UNITED STATES PATENT AND TRADEMARK OFFICE

APPLICATION NO.	FILING DATE	FIRST NAMED INVENTOR	ATTORNEY DOCKET NO.	CONFIRMATION NO.
10/064,605	07/30/2002	Ronald Scott Bunker	124626-1	6850

Office Action Summary	Application No.	Applicant(s)	
	10/064,605	BUNKER, RONALD SCOTT	
	Examiner	Art Unit	
	Raymond Alejandro	1745

DETAILED ACTION

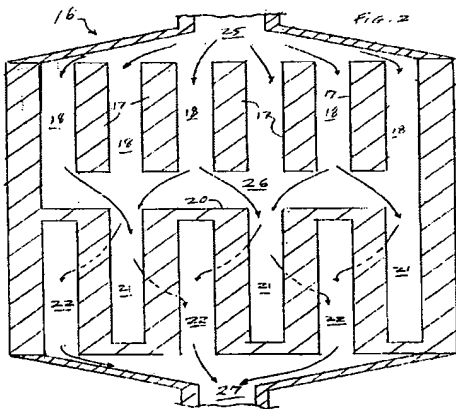
Figure 2 below depict the flow field plate comprising a base plate; and first and second side plate structurally connected to the ends of the base plate. The base plate includes ribs 17 defining flow-through flow field channels 18, and a serpentine rib 20 that defines inlet channels 21 and outlet channels 22 (SECTION 0013). It is also disclosed that the hybrid flow channels may be implemented in a flow field which folded one or more times (SECTION 0006). *Thus, if the channels are folded, the resulting plate structure will have channels laying one over another.*

Margiott also discloses a plurality of ribs 17 that project from the flow field plate and form recesses or indentations on the plate surface (SECTION 0013/ FIGURE 2). *Therefore, the ribs themselves also act as the claimed concavities.*

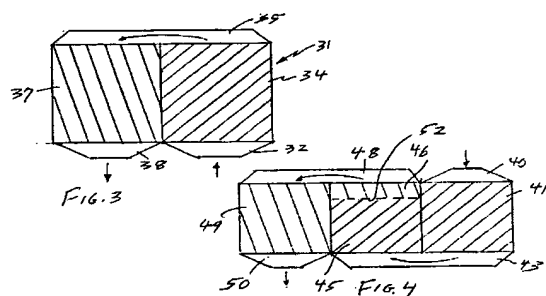
Figures 3-4 below illustrate the flow field plate in a folded configuration in which the oxidant enters through an inlet manifold 32, passes through a portion 34 of the plate having channels, then is turned by a flow reversing manifold 35 so as to flow through a portion 37 of the plate 31 which also has channels (SECTION 0014). In particular, Figure 4 shows the transition between the portions 34 and 37 not at the manifold 35 but mid-way between the manifold 35 and either of the manifolds 32 or 38 (SECTION 0014).

Hence, Margiott's flow field plate comprises a plurality of upper ribs and a plurality of bottom ribs forming top channels and bottom channels in the flow field plate per se to allow a flow of fluid to alternate between the top channels and the bottom channels.

Figures 3-4 above illustrate flow fluid plates in folded configurations wherein the flow reversing manifold or the transition between the plate portions and the flow-through flow field channels and the interdigitated flow field channels are disposed at the angle of substantially 90 degrees to provide the turns or reversing manifolds.
